PLANNING COMMISSION AGENDA

Tuesday, July 15, 2014
Breckenridge Council Chambers
150 Ski Hill Road

Breckenridge Distillery
Phase 3
1925 Airport Road

The Elk Permit Renewal
103.5 North Main Street

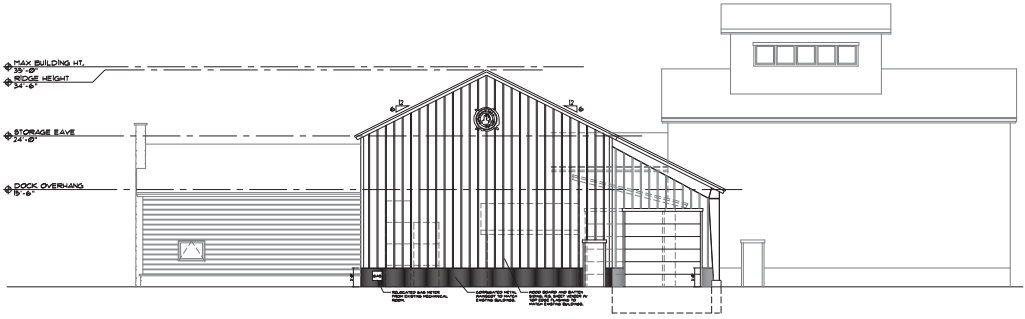
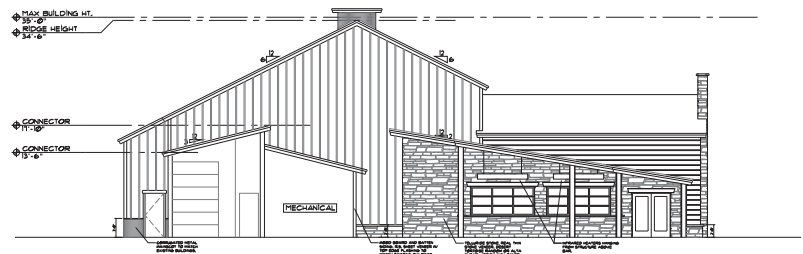
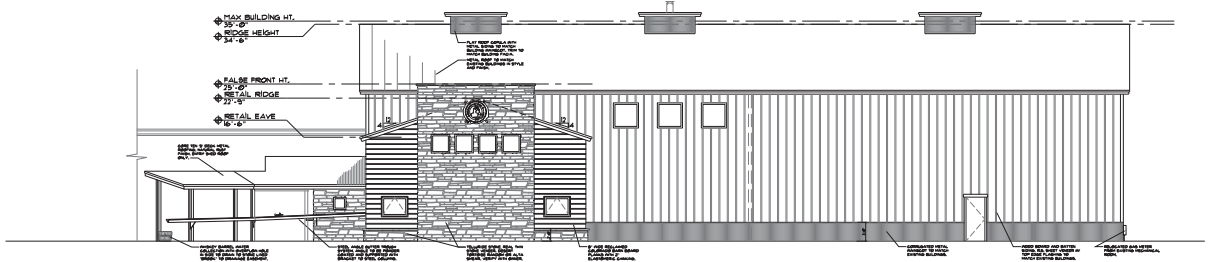
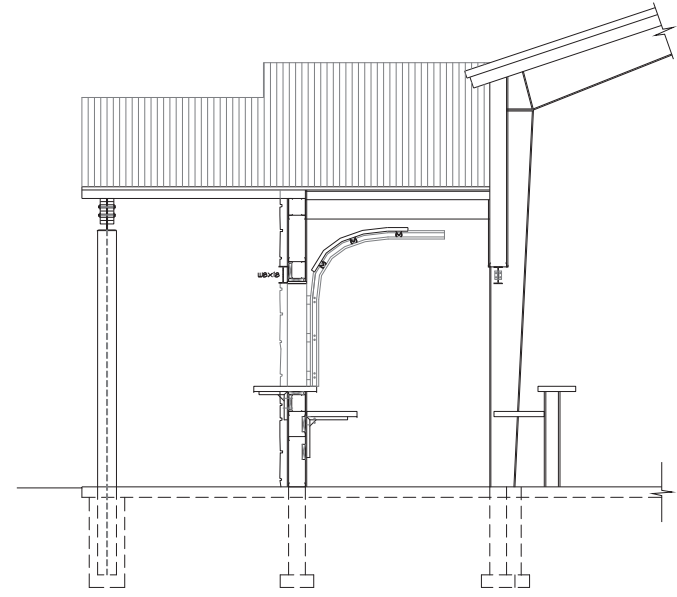
2. *Does the Planning Commission agree that the chimney/cupola elements on the elevation do not break up the roofline that is over 50' (designed at 125' in length) per Policy 6R?* The Planning Commission consensus was the long unbroken roofline of over 50' in length warrants negative one (-1) point.

Buildings are encouraged to provide broken, interesting roof forms that step down at the edges. Long, unbroken ridgelines, fifty feet (50') or longer, are discouraged. There is no breakup of the roofline proposed. Based on past precedence, staff has not considered the chimney-like elements such as those

shown on the plan elevations as being sufficient to break up the rooflines. Thus, this policy is not being met.

Connector roof code revision

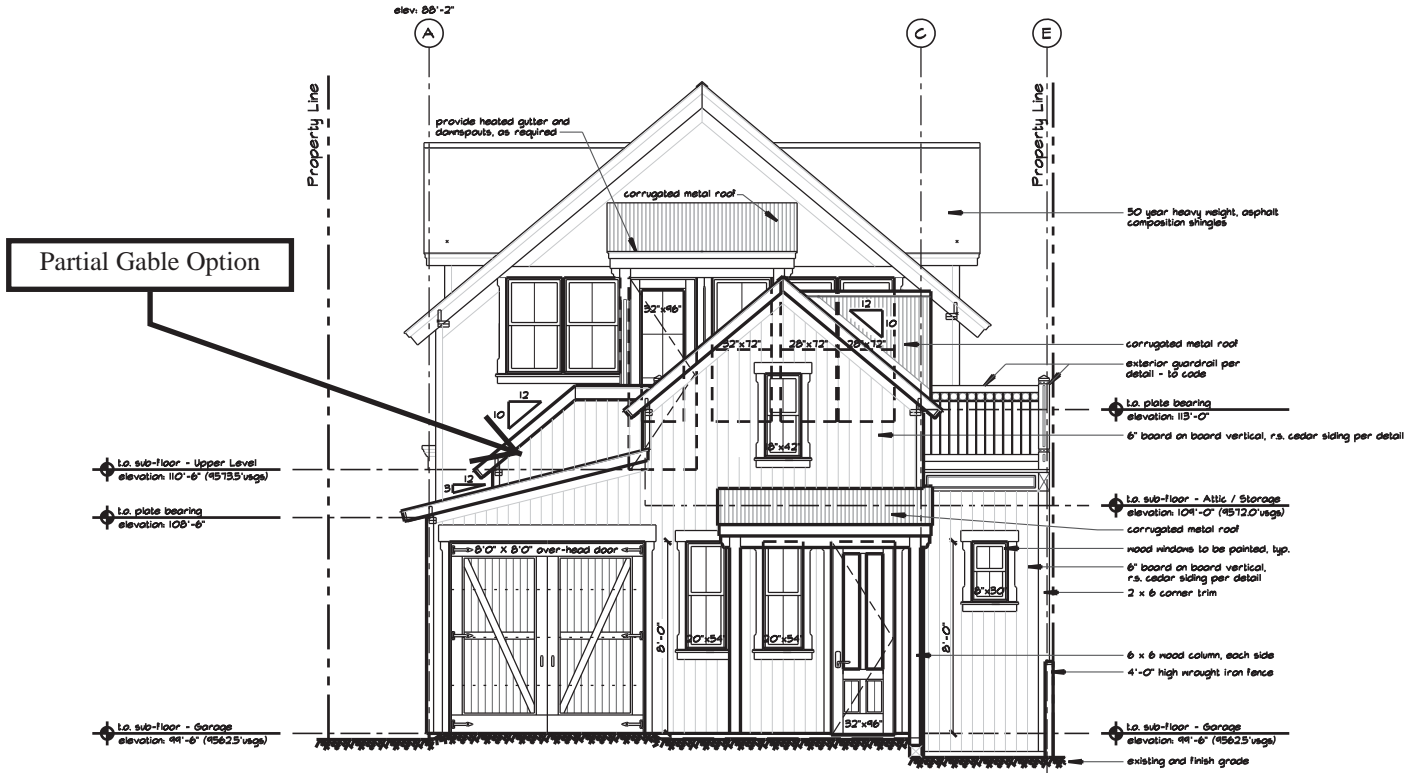
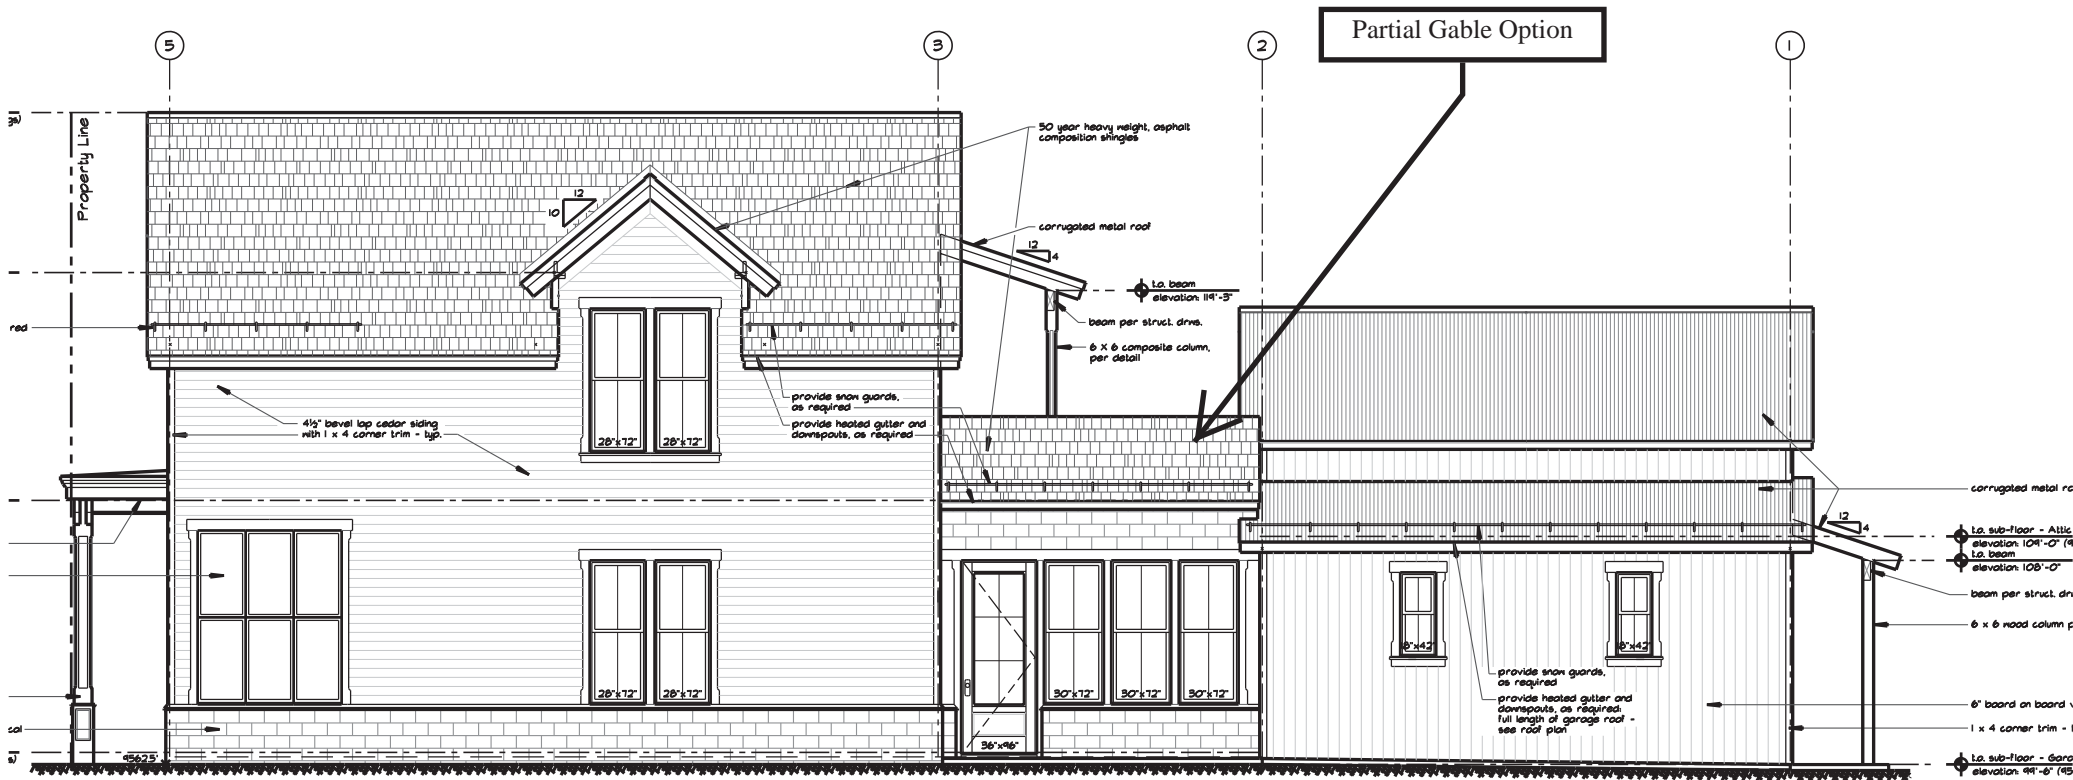
The second variance request, associated with this report, addresses item #6, “A connector shall be visible as a connector. It shall have a simple design with minimal features and a gable roof form”. The original plans did not have a simple gable roof form. Based on the plan/footprint of the connector in association with the previous variance request, a gable roof form would result in a connector that would be taller than the smaller module to be connected and would create a drainage condition on Lot 80 that would result in ice and water damage to the neighboring historic structure on Lot 81.

The applicant and agent would prefer to leave the flat roof as originally approved, but staff believes the shed element better describes the connector. The second variance is for not being able to provide a full gable roof form, just a partial gable.

The proposed drawings show a link that meets the intent of this policy on the north elevation. Though not meeting the exact criteria, the wall planes are set back two-feet, the height of the connector is clearly lower, and the separation of the larger masses is effectively accomplished by the length of the connector.
